UNITED STATES  
DEPARTMENT OF THE INTERIOR  
BUREAU OF LAND MANAGEMENT

FORM APPROVED  
OMB NO. 1004-0135  
Expires: July 31, 2010**SUNDRY NOTICES AND REPORTS ON WELLS**  
*Do not use this form for proposals to drill or to re-enter an abandoned well. Use form 3160-3 (APD) for such proposals.***SUBMIT IN TRIPLICATE - Other instructions on reverse side.**

COG Operating LLC respectfully requests to recompleate this well to the San Andres as follows:

**Jenkins B Federal 8  
30-015-29388  
COG Operating, LLC.  
September 30, 2014  
Conditions of Approval**

Jenkins B Federal #8

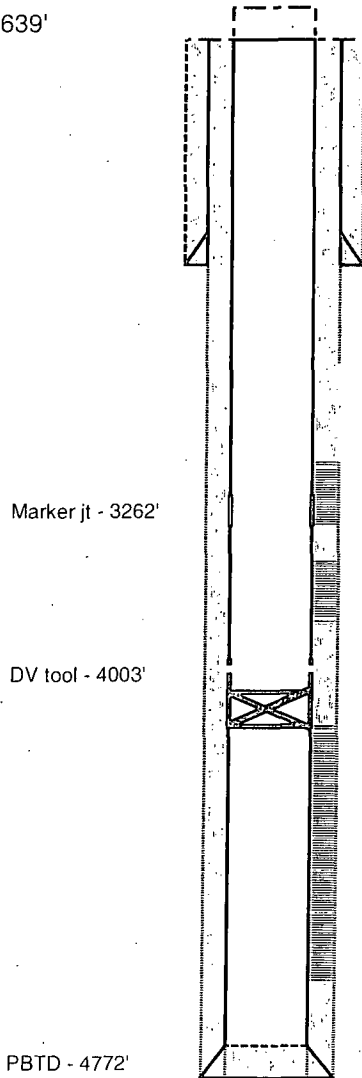
- 1. Operator shall set a CIBP at 4,250' and place 30sx Class C cement on top. Tag required at a minimum of 3,950' to seal the top of the Glorietta and DV tool.**

- 2. Must conduct a casing integrity test before perforating and fracturing. Submit results to BLM. The CIT is to be performed on the production casing to max treating pressure. Notify BLM if test fails.**
